## **Response to Action Item 19-157 Section 19.1**

### **PRA Issue List Regarding APR-1400, DCD Tier 2, SECTION 19.1**

#### **Issue # PRA-150 (AI 19-157)**

Figure 19.1-49 CET Quantification Results for Internal Events

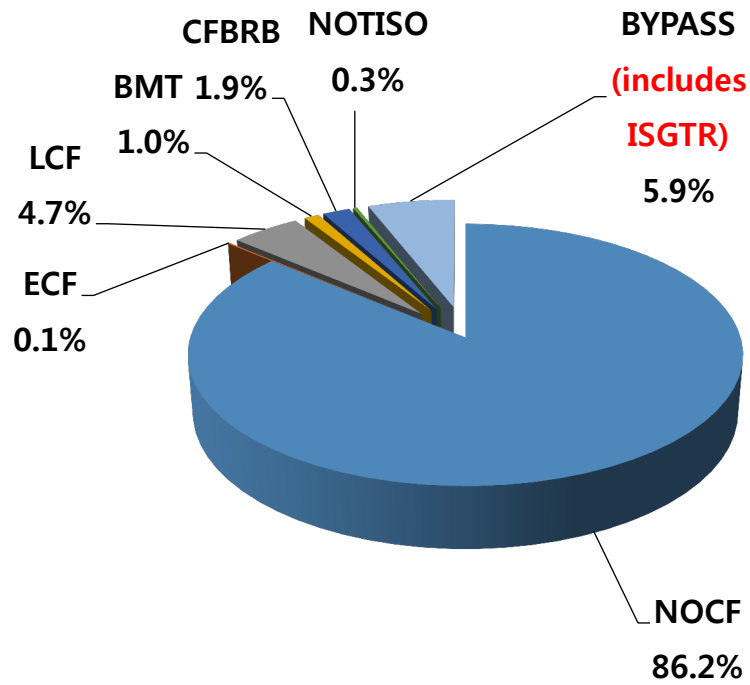
Containment event tree quantification results shown for internal events containment bypass on Figure 4-1 of APR1400-K-P-NR-013604-P, "APR1400 Design Certification Probabilistic Risk Assessment: Full Power Level 2 PRA: Quantification Notebook," Revision 0, July 2013, does not agree with the value provided in Figure 3-1. Using the values provided in Figure 3-1, the staff calculated a total frequency of containment bypass, which consists of PDS 1 through 4, to be  $6.43E-8$  /ry ( $2.41E-8 + 4.01E-8 + 1.18E-10 + 0.0E+00$  /ry). In contrast, Figure 4-1 shows frequency of containment bypass as  $7.75E-8$  /ry.

Both Figure 4-1 and DCD Figure 19.1-49 show a containment bypass frequency as 5.9% of CDF (DCD Figure 19.1-49 shows only percentage containment failure frequency values.).

PDS 1 and 2 are sequences with SGTR initiating events, and PDS 3 and 4 are ISLOCA sequences. All four are included to the Containment Bypass frequency shown in Figure 4-1 of APR1400-K-P-NR-013604-P and Figure 19.1-49 of the DCD. However, the Containment Bypass frequency in these figures also includes the severe accident- induced SGTR frequencies from PDSs 5 through 108.

Level 2 CET is a systematic calculation tool to quantify the containment bypass frequency including both sequences initiated by SGTR and induced SGTR sequences. The total bypass frequency of  $7.75E-08$  /ry is the quantification result including induced SGTR frequency from all the PDSs.

The DCD is revised to clarify the meanings, as shown in Attachment 1.
